HISTORIC AND DESIGN REVIEW COMMISSION

HDRC CASE NO: 2020-050
ADDRESS: 118 BOSTON
LEGAL DESCRIPTION: NCB 578 BLK D LOT 4
ZONING: RM-4, H
CITY COUNCIL DIST.: 2
DISTRICT: Dignowity Hill Historic District
APPLICANT: Robert Lee/LINDLEE LLC
OWNER: Robert Lee/LINDLEE LLC
TYPE OF WORK: Construction of a 1-story, single family residential structure
APPLICATION RECEIVED: January 20, 2020
60-DAY REVIEW: March 20, 2020
CASE MANAGER: Edward Hall
REQUEST:

The applicant is requesting conceptual approval to construct a 1-story, single family residential structure on the vacant lot at 118 Boston, located within the Dignowity Hill Historic District. This lot is located at the corner of Boston Street and Lowe Street.

1 NORTH/BOSTON ELEVATION
 SCALE : 3/16" = 1'-0"

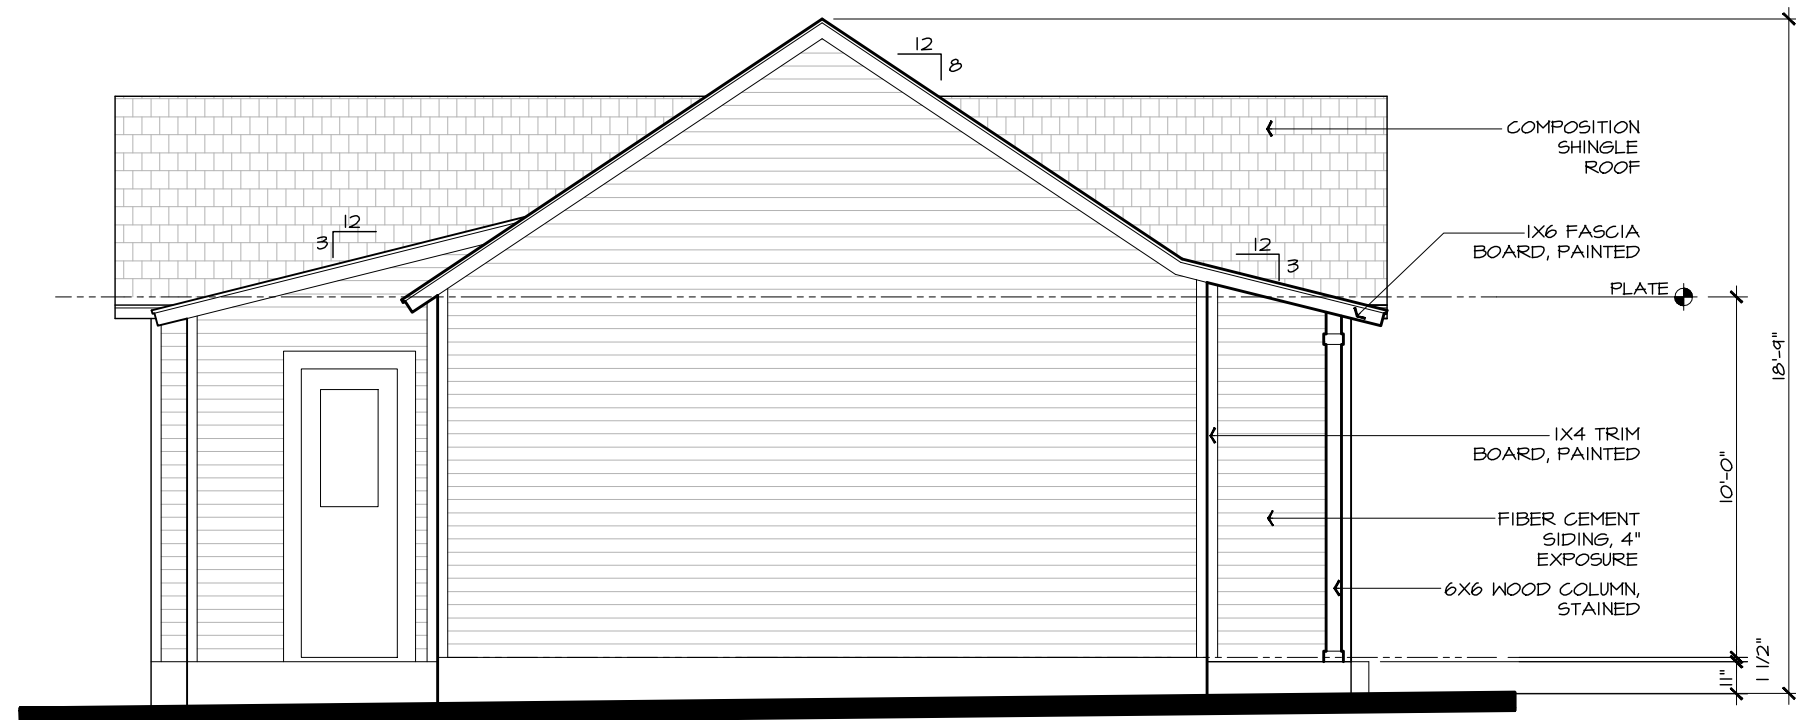
- e. **ENTRANCES** – According the Guidelines for New Construction 1.B.i. primary building entrances should be orientated towards the primary street. The applicant has proposed a primary entrance that is oriented toward Boston Street. Staff finds this to be appropriate and consistent with the Guidelines.

- h. **ROOF FORM** – The applicant has proposed roof forms that include both front and side gabled roofs. The applicant has proposed for the side gabled roof to feature a shorter ridge line than that of the intersecting gable, resulting in a dormer-like element. Staff finds this to be inappropriate, and that the applicant should modify the roof forms to feature a matching ridge height. This can be accomplished either through the raising or lowering of either of the existing ridge lines, or through the creation of a hipped form to tie into the rear of the side gabled roof form.

- m. **ARCHITECTURAL DETAILS** – Generally staff finds the proposed architectural details to be appropriate; however, staff finds that the applicant should modify the proposed ridge heights, as noted in finding h.

- ii. That the applicant modify the proposed ridge heights to result in both gabled forms featuring a matching ridge height, or incorporate a hipped element to tie into the rear of the side gabled roof to reduce the taller ridge line's visibility as noted in findings h and m.

2 SOUTH/REAR ELEVATION
 SCALE : 3/16" = 1'-0"

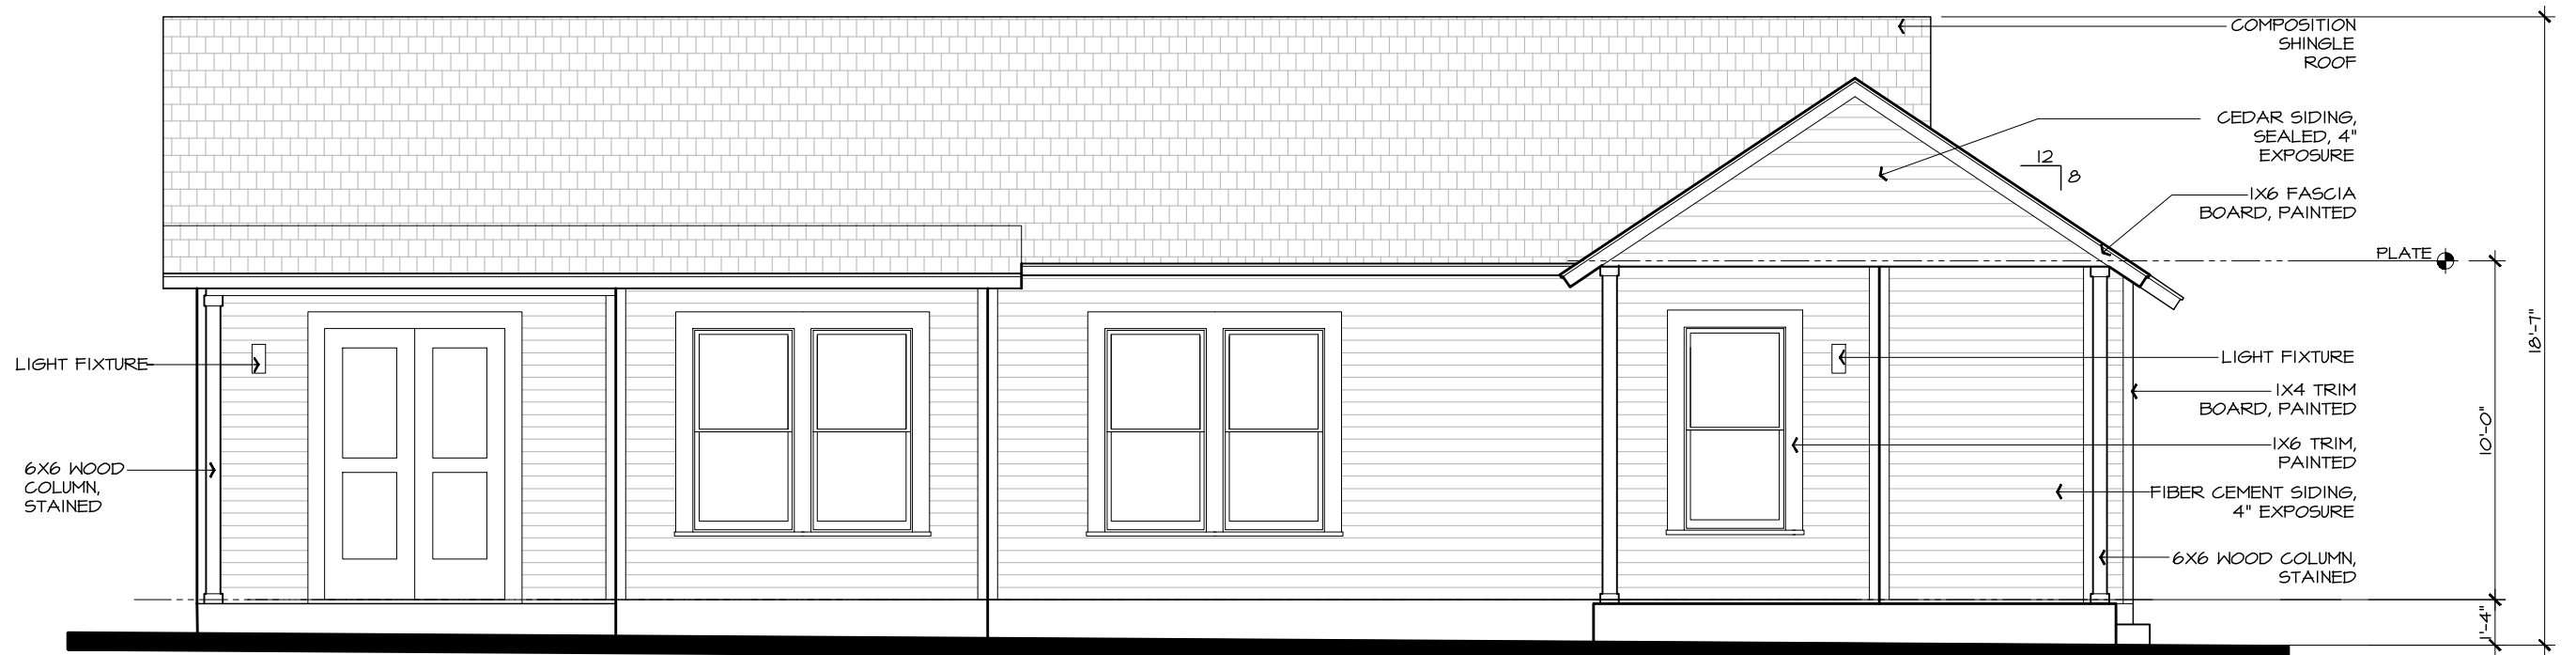
- l. **FENESTRATION PROFILE** – The applicant has proposed a number of windows that feature traditional sizes and profiles, including one over one and two over two profiles. Generally, staff finds the proposed fenestration profiles to be appropriate and consistent with the Guidelines. Staff finds that the applicant should study the introduction of fenestration on the rear elevation.

- vii. That all mechanical equipment be screened from view from the public right of way as noted in finding p.
- viii. That the applicant explore incorporating fenestration into the rear façade.
